Group Art Unit: 2813

REMARKS

Response to Examiner's Arguments

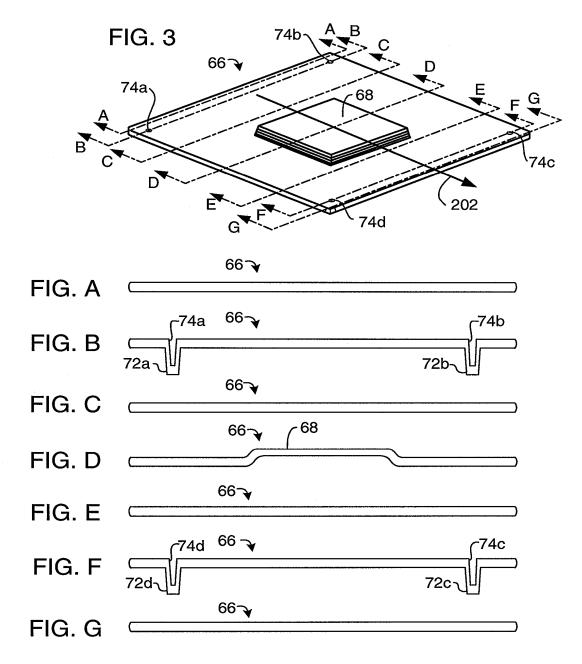
"Because applicant's description of the cross-sectional profiles of fig. 3, fig. A, fig. B and fig. C in page 4 of the Remark (*sic*) are not taught by Hawthorne et al."

"Applicant's cross-sectional profiles are between pins 74a and 74d for cross-sectional profile A, cross-sectional profile through 68 for cross-sectional profile B, and between pins 74b and 74c for cross-sectional profile C."

"However, Hawthorne et al. teaches at figure 4, the cross-sectional profile is between pins 74a/72a to 74b/72b, and with channel 68 between pins 74a/72a and 74b/72b."

"Since, figure 3 is not in scale, hence, the cross-sectional profile of figure 4 is coming from the redrawn figure 3 as shown below having channel 68 formed between pins 74a/72a and 74b/72b and extended to between pins 74d and 74c."

"Therefore, Hawthorne et al. clearly teaches the claimed limitation of a cross-sectional profile of the plate (70) [sic] that is substantially constant along at one horizontal direction that is perpendicular to the cross-sectional profile (between pins 74a/72a and 74b/72b) of the plate (70) [sic]."

Applicants have corrected the element numbers in the previously provided Hawthorne FIG. 3 and provided more cross-sectional profiles in FIGs. A-G to assist in better understanding Hawthorne.

The FIGs. are now correctly labeled so it can be seen that each Hawthorne cross-sectional profile is not substantially constant, but changes.

While the FIGs. have been clarified, it is obvious from Hawthorne FIG. 3 that the heat spreader 66 is symmetrical regardless of whether the cross-sectional profile is between pins 74a/72a and 74d/72d, 74a/72a and 74b/72b, 74b/72b and 74c/72c, or 74c/72c and 74d/72d.

Thus, it does not make a difference that the cross-sectional profile is taken between different pins than shown in FIG. 4. However, Applicants have provided Hawthorne FIG. 3 with cross-sections taken through Hawthorne FIG. 3 as FIGs. A-G below:

From the above, it is obvious that a Hawthorne cross-sectional profile is shown in FIG. A and that the arrow 202 is a horizontal direction perpendicular to that cross-sectional profile. It is also obvious that the Hawthorne cross-sectional profile changes from FIG. A to FIG. B, from FIG. B to FIG. C, from FIG. C to FIG. D, from FIG. D to FIG. E, from FIG. E to

FIG. F, and from FIG. F to FIG. G along the horizontal direction. Even when accounting for scale, one having ordinary skill in the art would not consider the cross-sectional profile to be substantially constant. The Examiner is reminded also that the Examiner's reading is not in conformance with the requirement that:

The scale is not relevant because FIG. 3 discloses changes in cross-sectional profile to those having ordinary skill in the art. To the extent that the remainder of the above comment can be understood, Hawthorne element 68 is not a channel but a <u>central</u> die receiving section, which is raised above the surrounding surface, as shown in Hawthorne FIGs. 4 and 5 and Hawthorne col. 5, lines 30-31.
